# National Transportation Safety Board

## Safety Recommendation

In reply refer to: A-98-6

Figure 1. Aileron Wing Control Cable System.

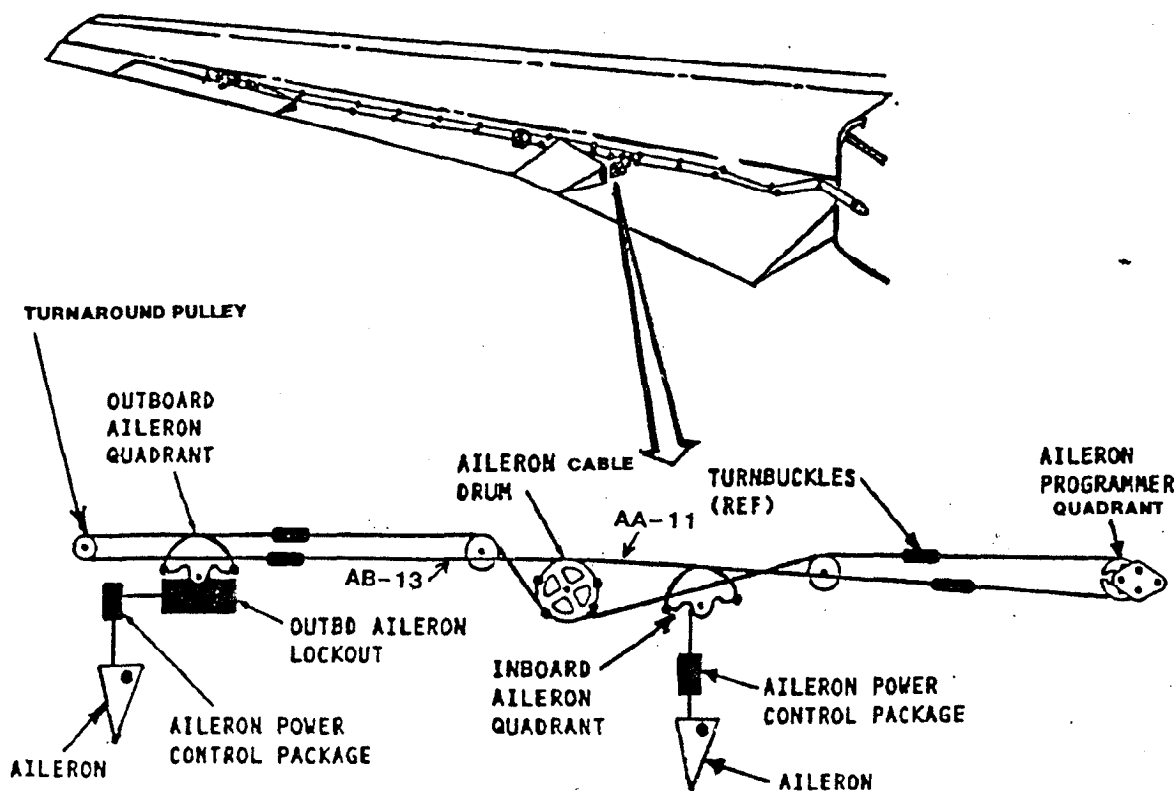
Each wing has two AA and two AB aileron cable assemblies (see Figure 1.), one inboard and one outboard. The inboard AA cable run connects the aileron programmer quadrant to the aileron cable drum, and the inboard AB cable run connects the same quadrant to the inboard aileron PCU quadrant. The outboard AA cable run connects the aileron cable drum to the outboard aileron quadrant, and the outboard AB cable run connects the drum to the same quadrant via a turnaround pulley. The aileron cable drum, which is located at wing station (WS) 776.98, is a four-slotted pulley with a guide pin and is used to provide a complete (closed) cable loop to the inboard aileron even if the outboard segment is lost because of malfunction. The guide pin's purpose is to ensure that all four cables remain in the correct pulley slots at all times.

Further investigation by BASI revealed that the two aileron control cable decals<sup>1</sup> on the aileron cable drum's inboard and outboard mounting brackets at WS767 and WS780 were installed incorrectly. The decal for WS767 was fitted at WS780 and vice versa. BASI also found that a similar 747 aircraft, S/N 23028, production line number 584, had the aileron cable replaced because of excessive wear, and the cable was frayed down to one remaining strand. This aircraft also had the two aileron control cable decals on the aileron cable drum's inboard and outboard mounting brackets at WS767 and WS780 fitted incorrectly and interchanged. Because of the decals' transposition, the Safety Board requested a U.S. operator to randomly inspect its 747 airplane aileron control systems for the aileron cable drum decal identification at WS767 and WS780. An inspection on November 24, 1997, of one 747-251, S/N 21707, production line number 378, revealed similar decal transposition on the right WS767 and WS780.

According to Boeing, if these decals are interchanged during installation, the transposition results in incorrect cable routing information at the aileron cable drum and may lead to incorrect cable positioning during installation. A review of the applicable engineering drawings shows that instructions for the decal installations are correct. A check of undelivered 747s at the Boeing factory (production line number 1130 and onward) revealed correct decal installations.

The BASI investigation concluded that the Brisbane incident was caused by misrouting of cables on the aileron cable drum at WS776.98 and that transposition of the aileron control cable decals on the aileron cable drum at WS767 and WS780 has the potential to cause misalignment of the aileron control cables during installation. The Safety Board is concerned that airplanes with mispositioned aileron cable installation decals may be susceptible to aileron cable failures in flight, which could jeopardize flight safety. The Safety Board believes that the Federal Aviation Administration should issue an airworthiness directive to require operators of 747s, produced before production line number 1130, to conduct a one-time inspection of the aileron control system to ensure correct routing of aileron control cables on the aileron cable drum located at WS776.98 and correct installation of aileron cable decals at WS767 and WS780 at the earliest possible inspection interval.

Issue an airworthiness directive to require operators of Boeing 747 airplanes, produced before production line number 1130, to conduct a one-time inspection of the aileron control system to ensure correct routing of the aileron control cables on the aileron cable drum located at wing station (WS)776.98 and correct installation of aileron cable decals at WS767 and WS780 at the earliest possible inspection interval. (A-98-6)
